**RE: 2650 ST. CLAIR AVENUE WEST**

**APPLICATION FOR SITE PLAN APPROVAL  
CITY FILE NO. 22 142181 WET 05 SA  
OLT FILE NO. OLT-23-000054**

**OFFER TO SETTLE**

DRAWING TITLE  
**SITE PLAN**

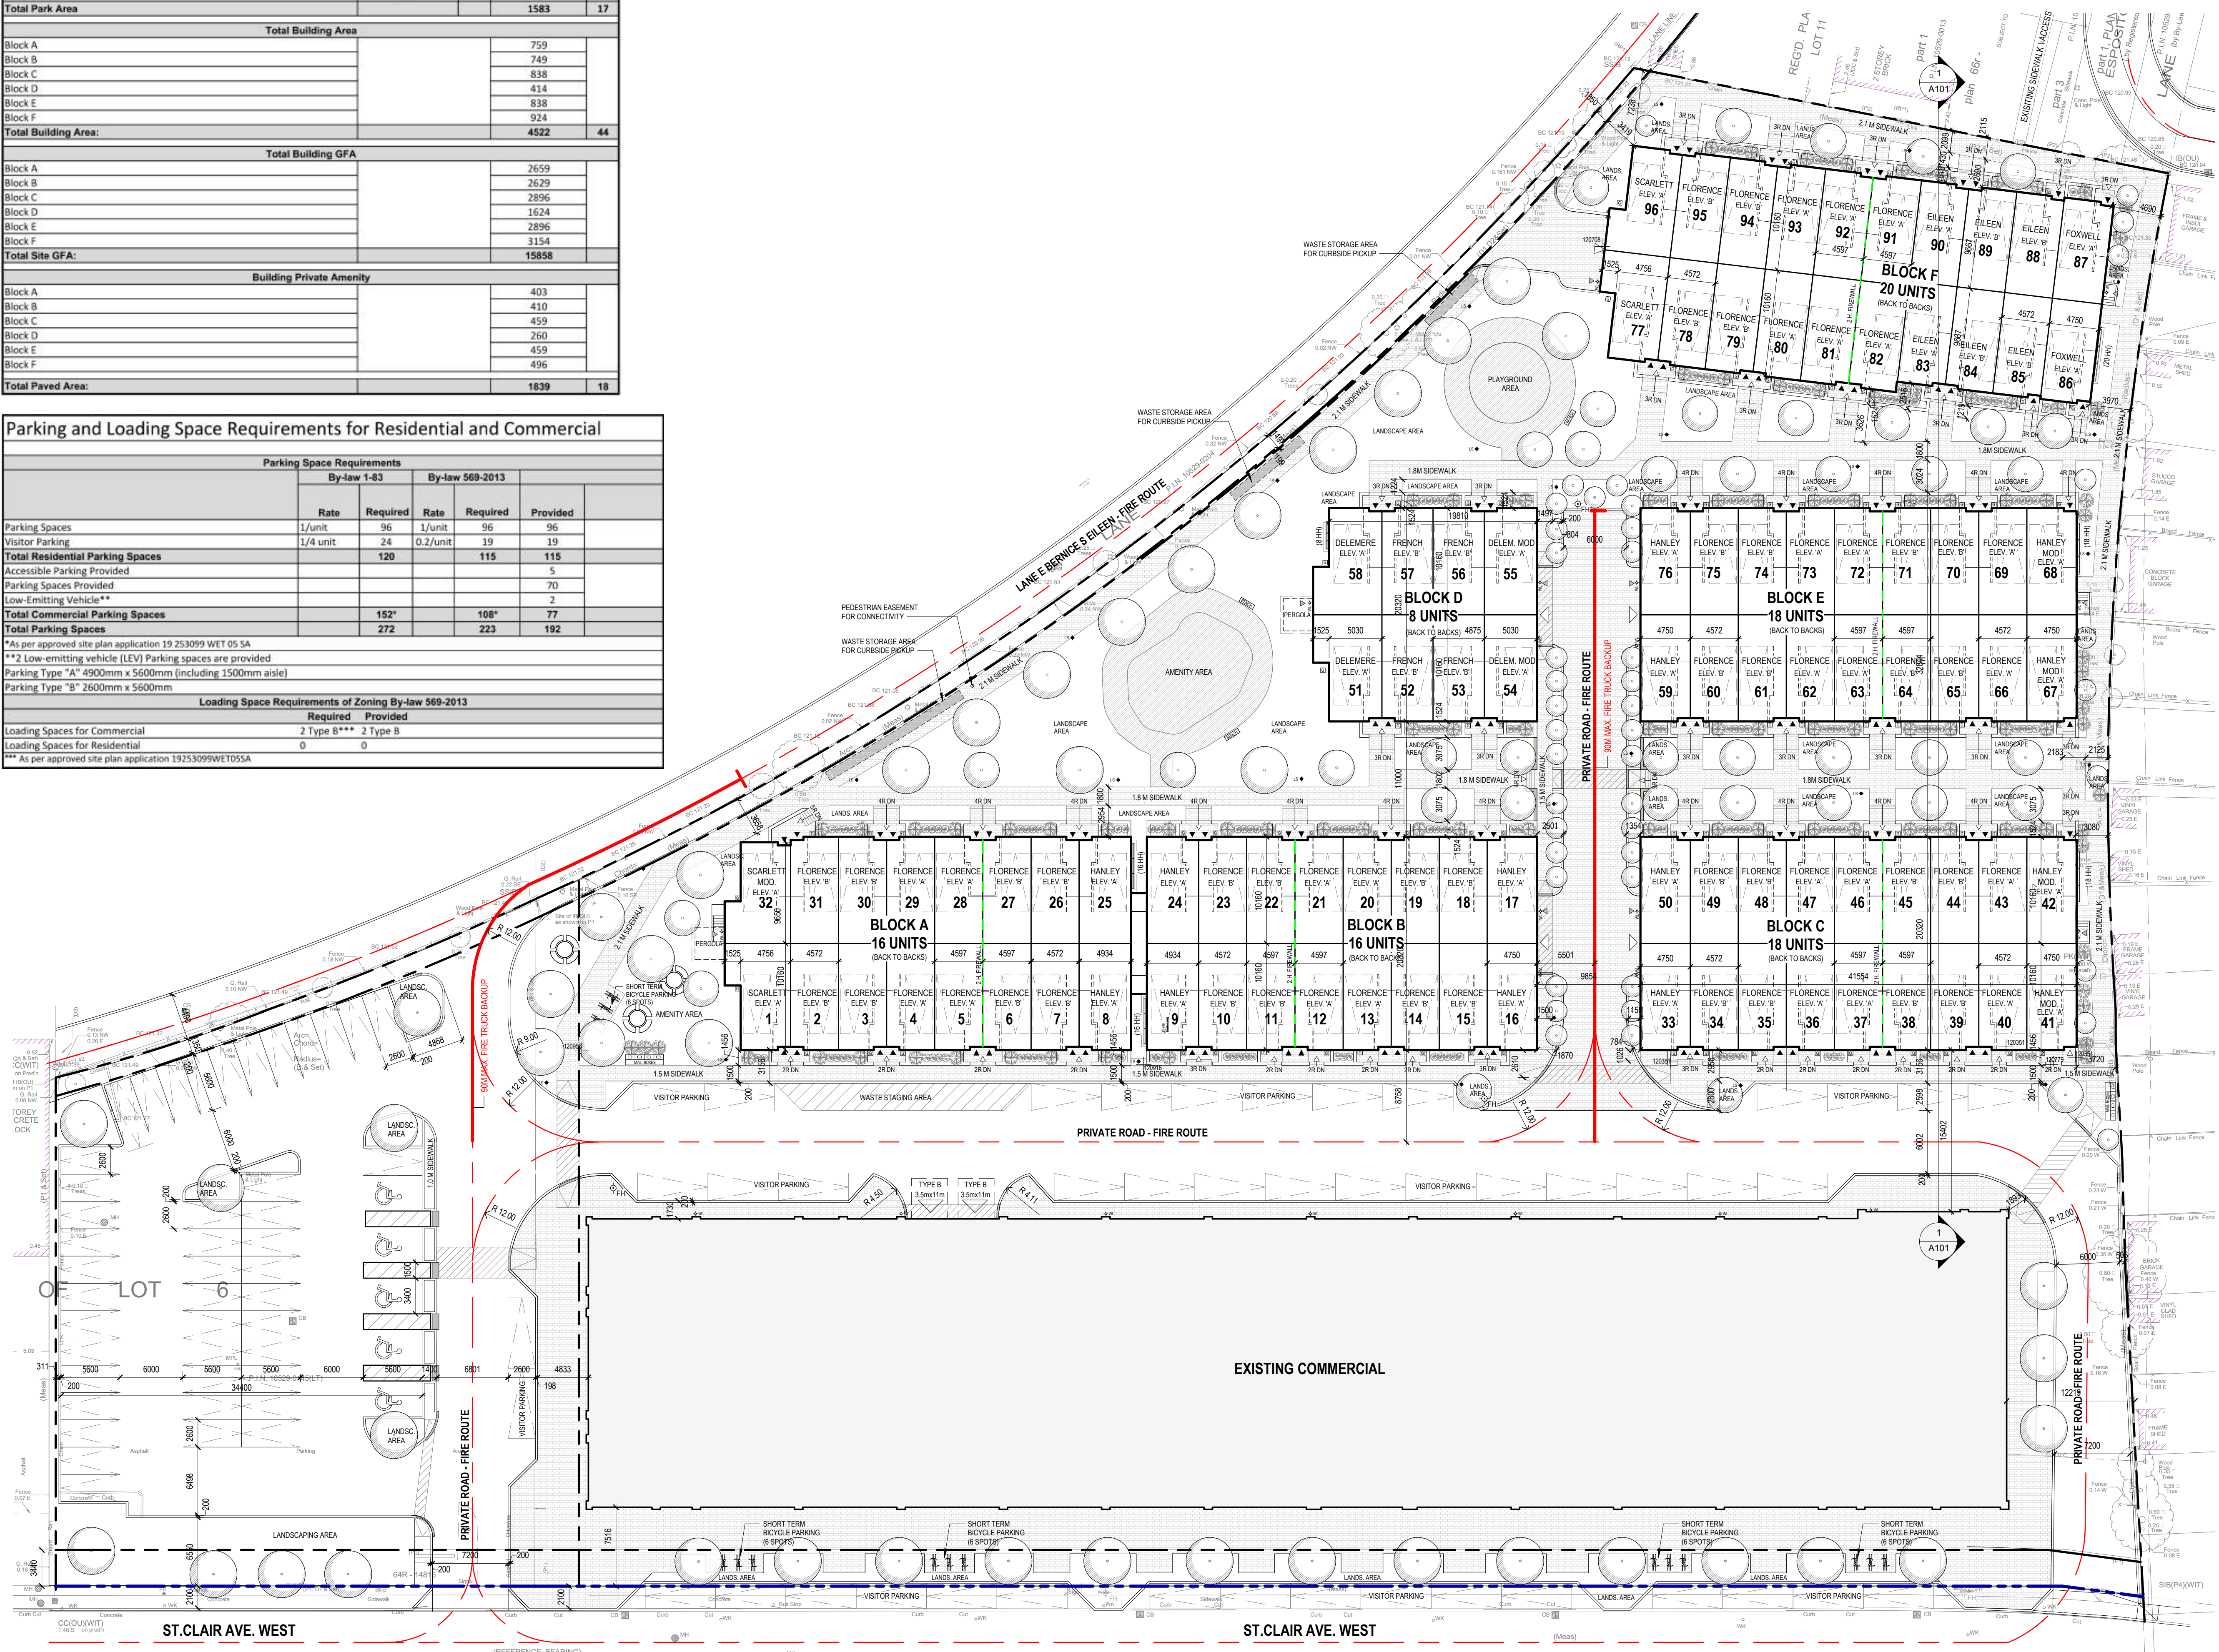
1. *Revised waste management plan must remove references to private waste collection. New developments must be designed to allow for City waste collection services and meet the Solid Waste requirements for new developments. Currently, the waste management plan and site plan drawings do not comply with this. Please contact Solid Waste for details required in waste management plans.*

2. *Proposed cart storage in garages does not meet minimum requirements for waste storage. Revised drawings must indicate a waste storage room(s) that total a minimum 49 square meters in size. They must be located in areas that are convenient to all residents. The currently proposed waste storage is shared curbside bins in individual waste storage areas that do not meet minimum requirements.*

3. *Revised drawings must indicate a bulk storage room of minimum 10 square metres. The currently proposed bulk waste storage is shared within a design that mimics an individual waste storage area that do not meet minimum requirements.*

4. *Revised drawings must indicate and annotate a Type G loading space that is 13 metres in length, 4 metres in width, has an unencumbered vertical clearance of 6.1 metres, is level (+/-2%), and is constructed of a minimum of 200 mm reinforced concrete. No loading has been provided.*
5. *Revised drawings must indicate and annotate a staging pad abutting the front of the Type G loading space that will be at least 5 square metres, have an unencumbered vertical clearance of 6.1 metres, constructed of 200mm reinforced concrete and have a grade of no more than 2%. No staging has been provided.*

6. *Revised drawings must indicate that all access driveways to be used by the collection vehicle will be level (+/-8%), have a minimum vertical clearance of 4.4 metres throughout, a minimum 4.5 metres wide throughout and 6 metres wide at point of ingress and egress. No notations provided.*

7. *Revised drawings must indicate and annotate a collection vehicle movement diagram that has a length of 12 metres and a width of 2.4 metres with a minimum inside/outside turning radii of 9.5 metres and 14 metres respectively, when entering, exiting, travelling throughout the site and entering/exiting the type G loading space. The diagram must also indicate the ability of the collection vehicle to enter and exit the site in a forward motion with no more than a three-point turn. Incorrect waste collection vehicle movement diagram provided.*

8. *If the planned movement of the collection vehicle is adjacent to exits from the parking garage revised drawings must indicate a warning system to caution motorists leaving the parking garage of heavy vehicles when loading operations are occurring. This warning system should include both lights and signs.*

**Response:** As discussed with staff in coming to a settlement of OLT 22-002 547, waste collection for the site will be private. Dunpar will therefore make an application to the City's Waste Services General Manager to opt out of Toronto solid waste collection services in perpetuity. Accordingly, the references to private waste collection are appropriate.

**Response:** The storage spaces in the garages for each residential block (as identified in the Waste Management Plan) provide sufficient space for the storage of carts to be used in the curb-side collection system for the development. The number of carts was determined based upon volumetric calculations for the quantity of waste materials generated from each block of townhouses on a weekly basis.

**Response:** Bulk waste storage areas have been identified based on the requirements for each of the residential blocks.

**Response:** These requirements do not apply since 2650 St. Clair Ave W will have a privately operated curb-side collection system for.

**Response:** The locations of the set-out areas along the internal roadways have been identified in the Waste Management Plan, and access will be from St. Clair Ave. W.

**Response:** Tetra Tech has prepared revised drawings depicting vehicle collection movements and the warning system, which it will provide to City staff.
